**ADDENDUM  
NO. 2**

**November 4, 2021**

**Portage Township School - Bid Package #2  
PHS Learning Lab, Elementary Schools Media Centers, and Office Renovation  
Portage IN, 46368**

## ADDENDUM NO. 2

SUBSET OFFICE SHEET NO. **A6.0**

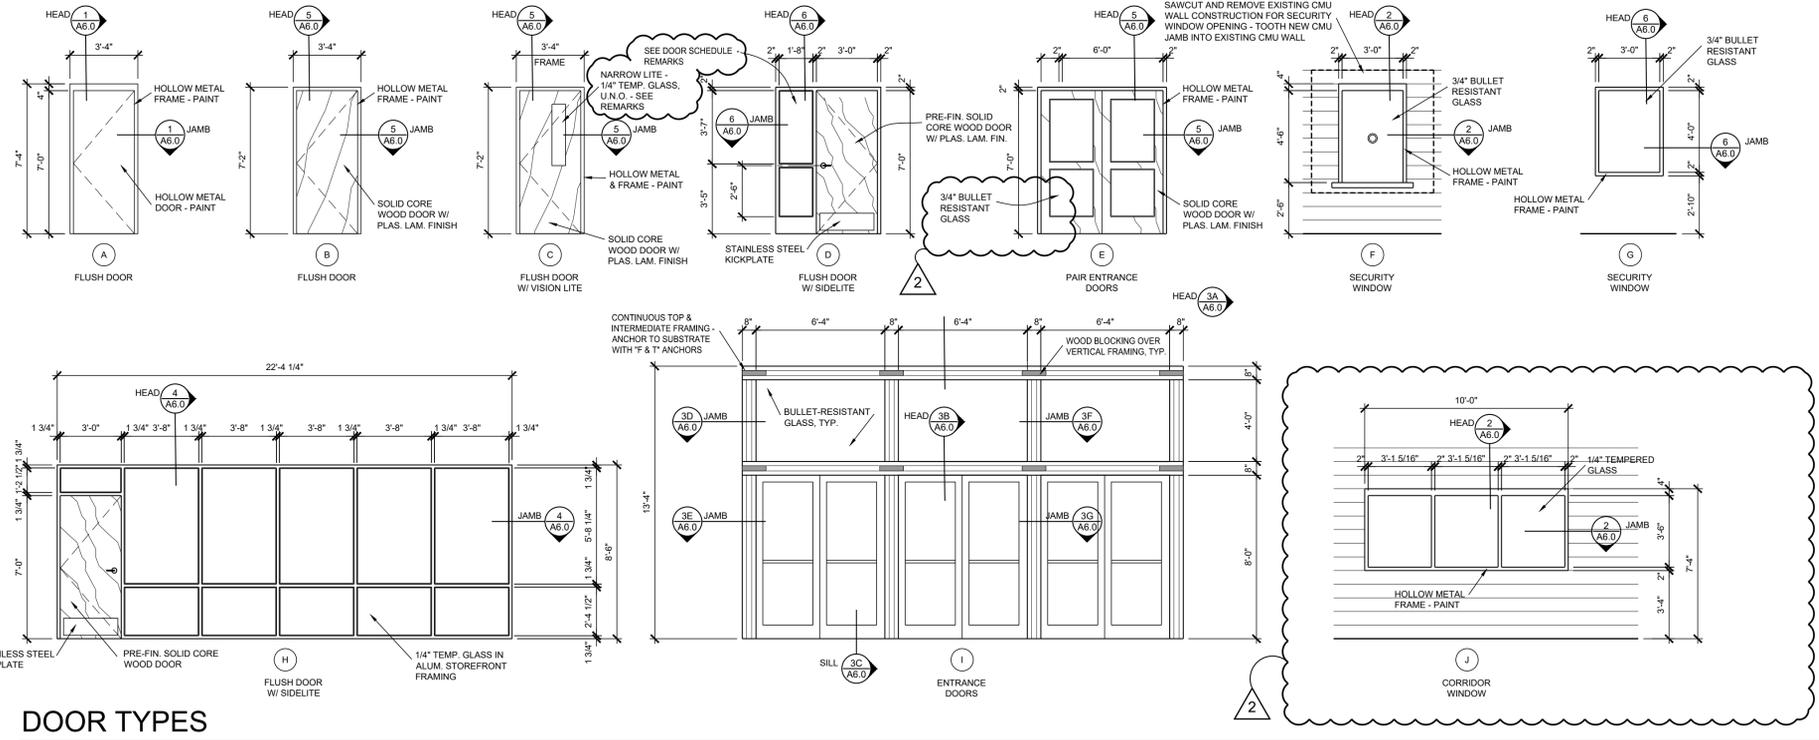
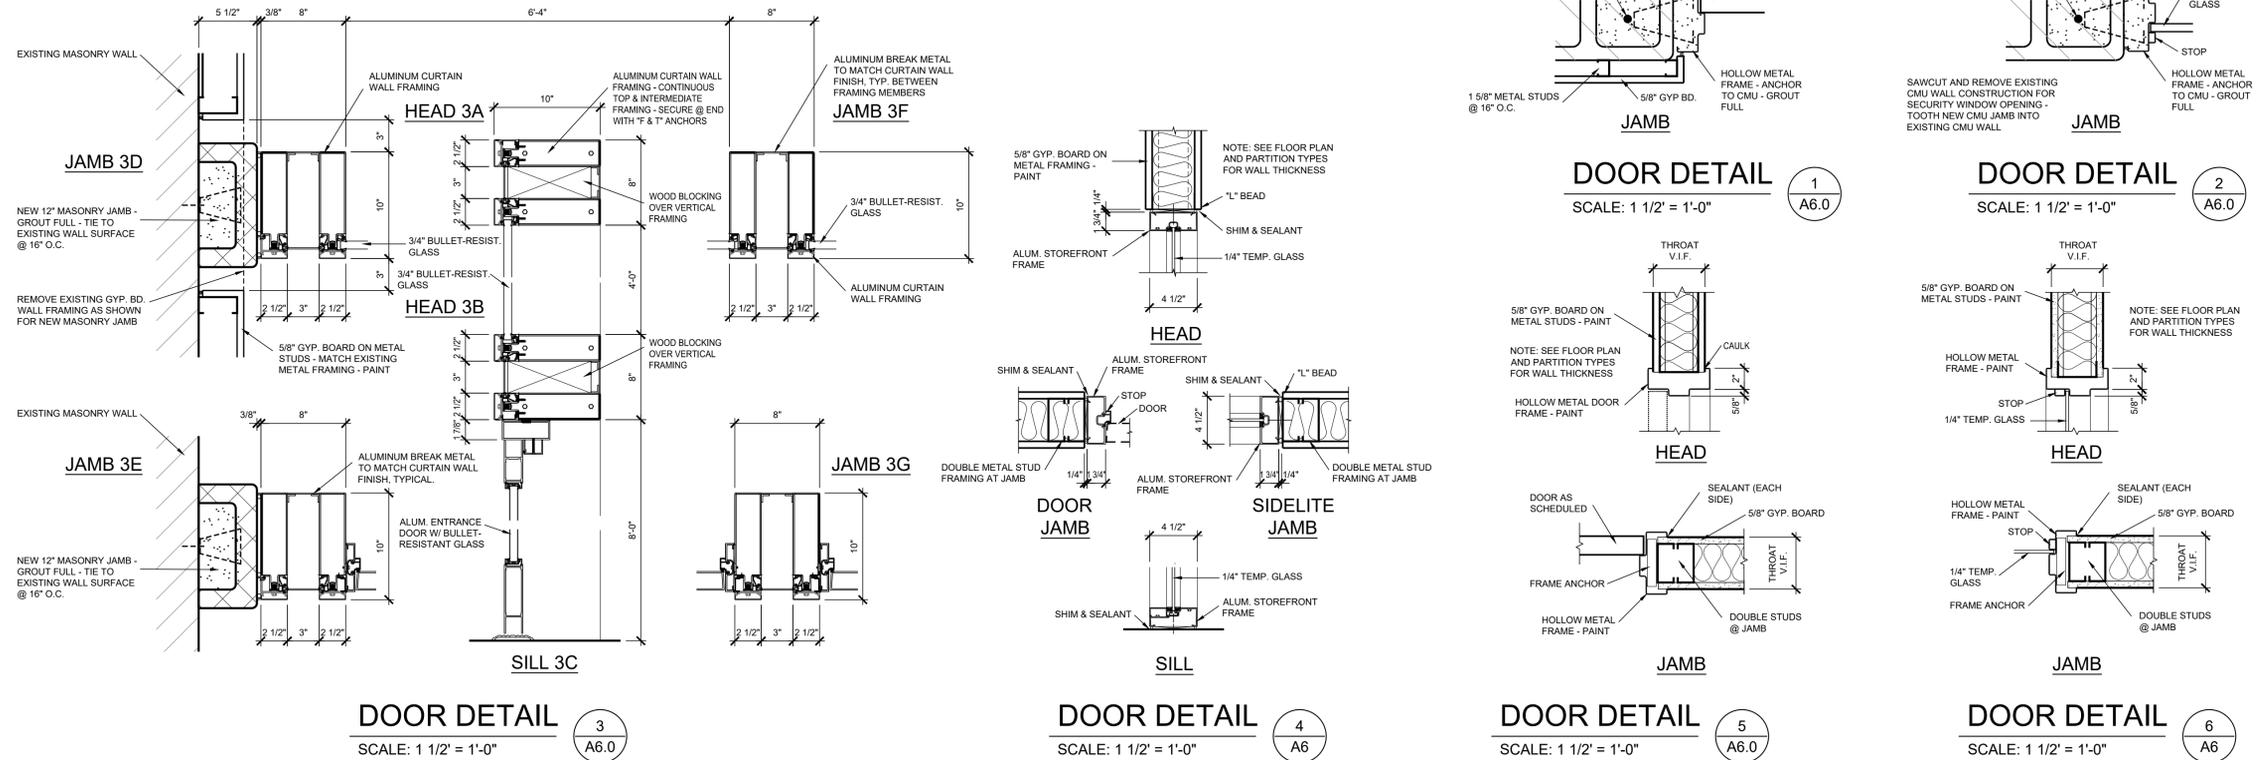
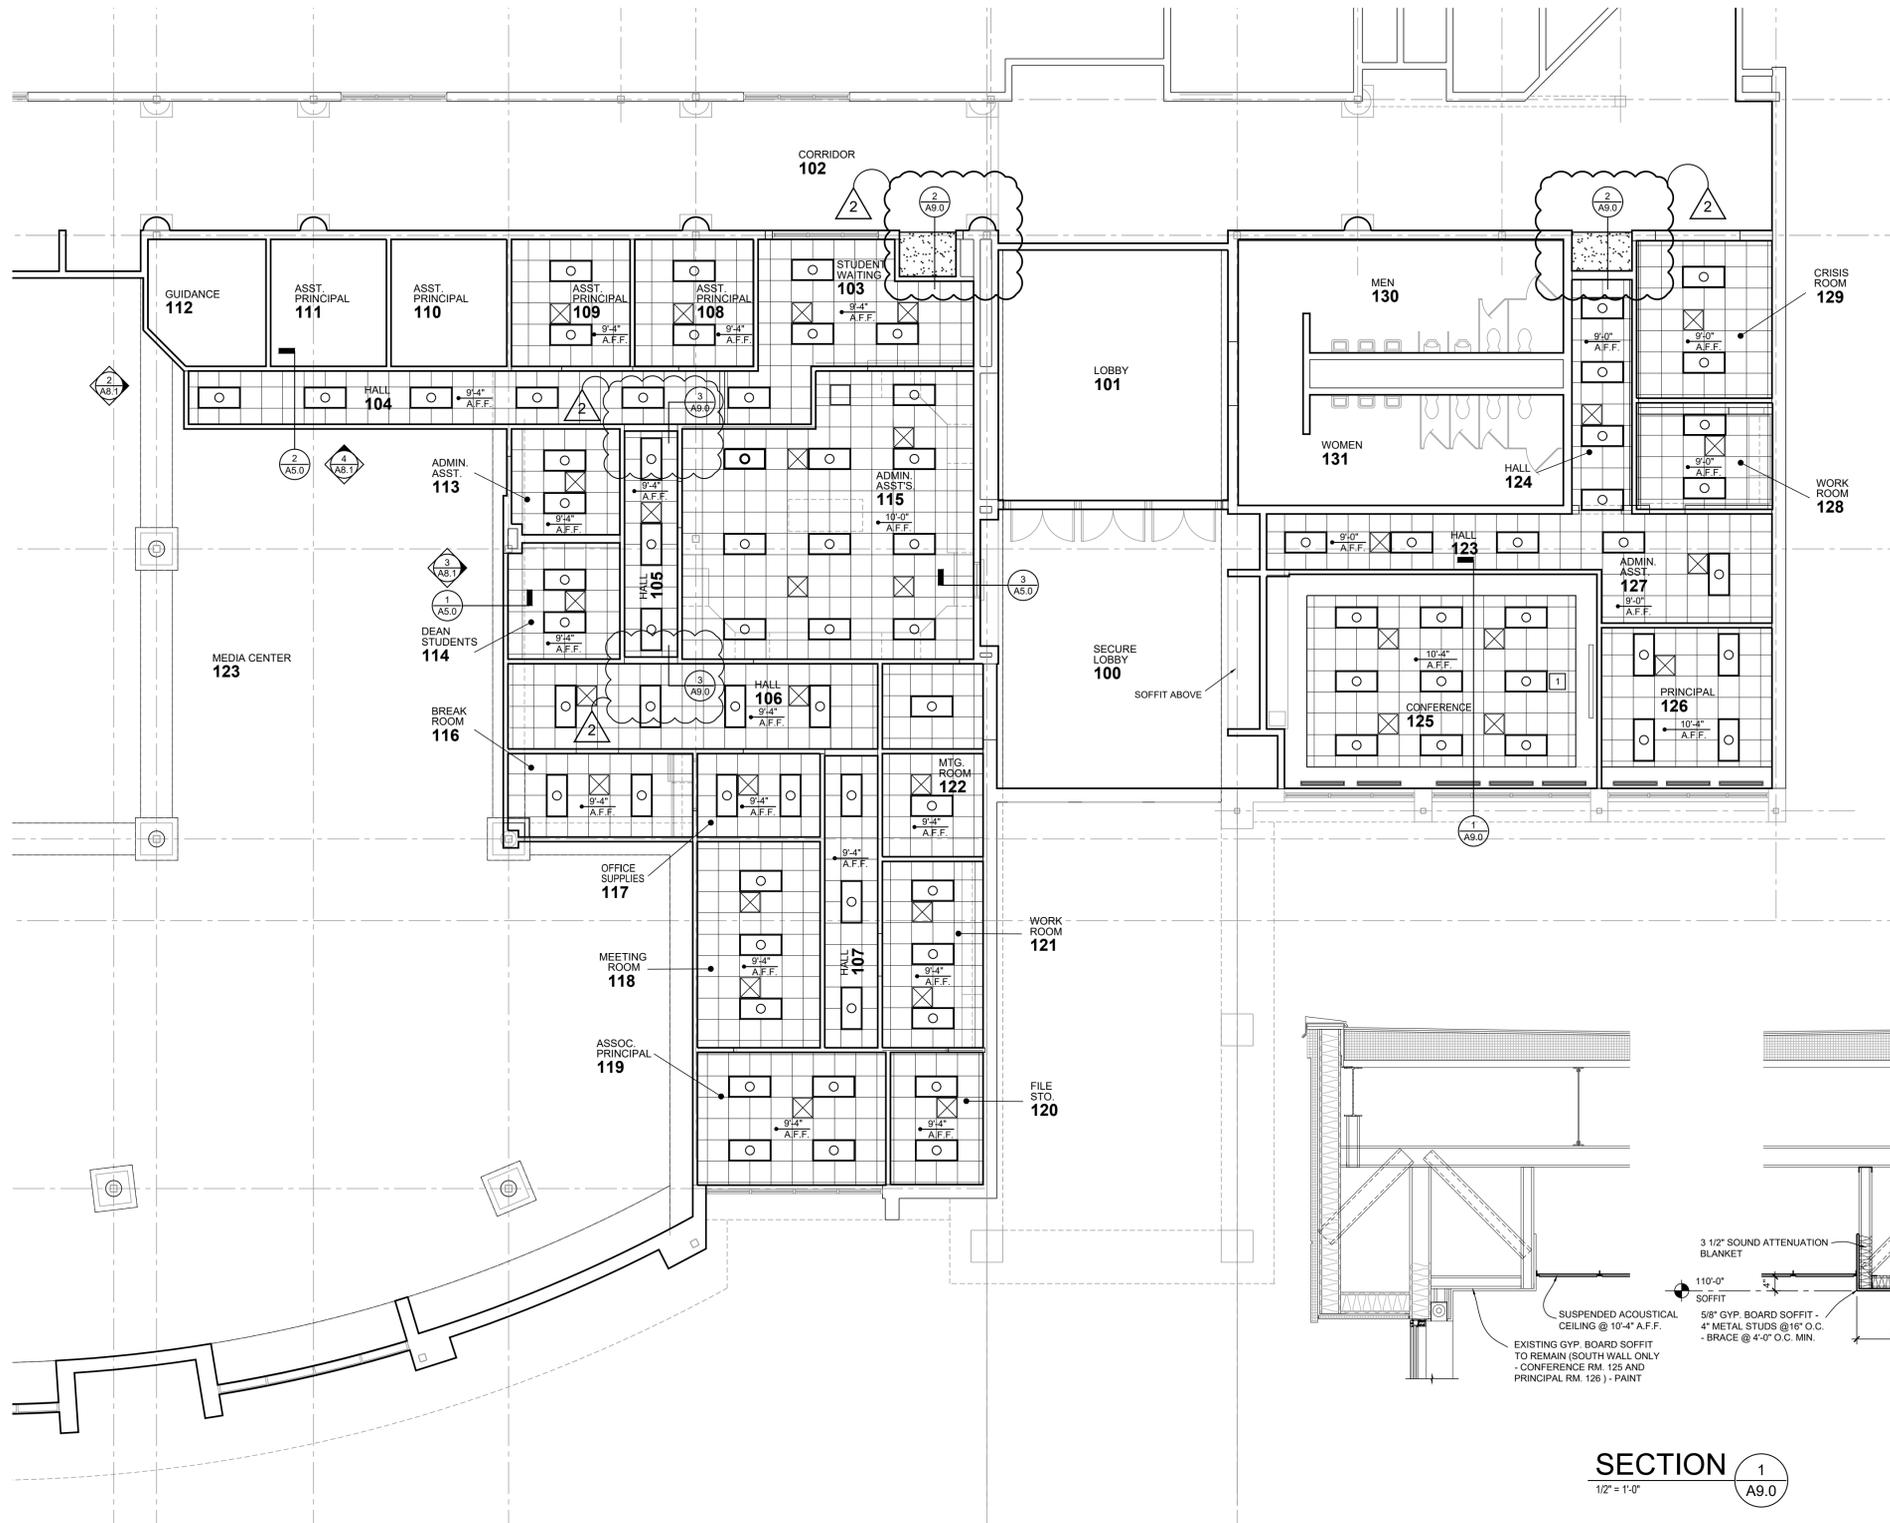
29. **DRAWINGS**; Sheet No. OFFICE A6.0; Replace this sheet in its entirety. Note revisions to Door Schedule and addition of Door Type J.
30. **DRAWINGS**; Sheet No. OFFICE A7.0:

### REFLECTED CEILING PLAN

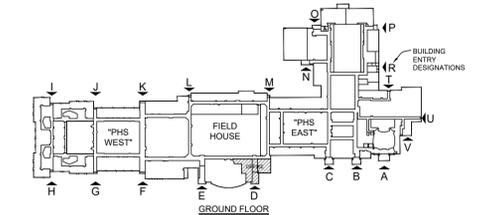
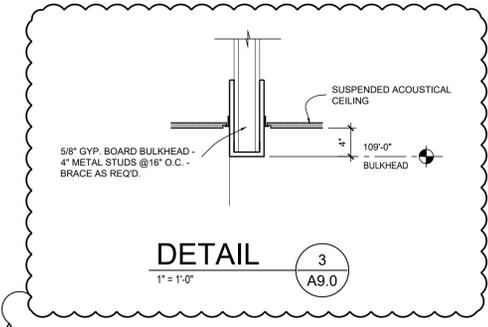
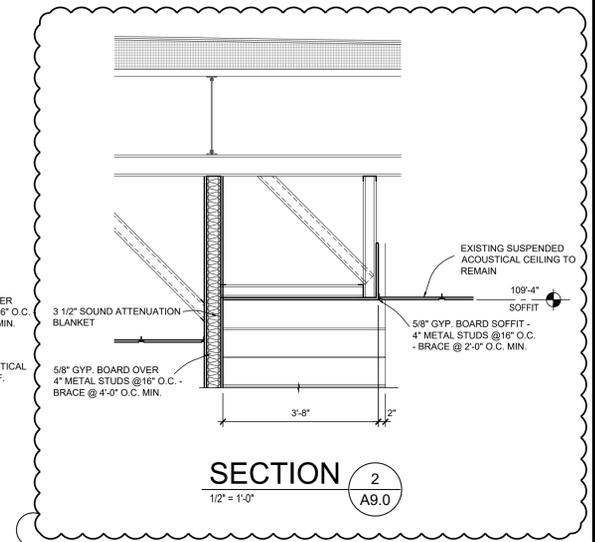
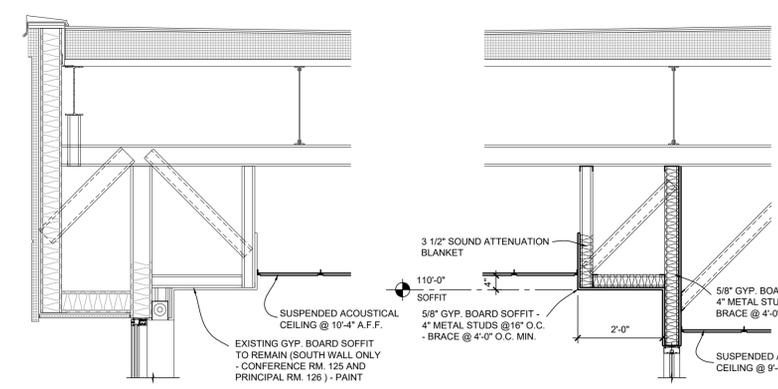
32. **DRAWINGS**; Sheet No. OFFICE A9.0: Replace this sheet in its entirety. Note inclusion of soffits at corridor entries to Student Waiting 103 and Hall 123 and addition of Section 2/A9.0 and Detail 3/A9.0.
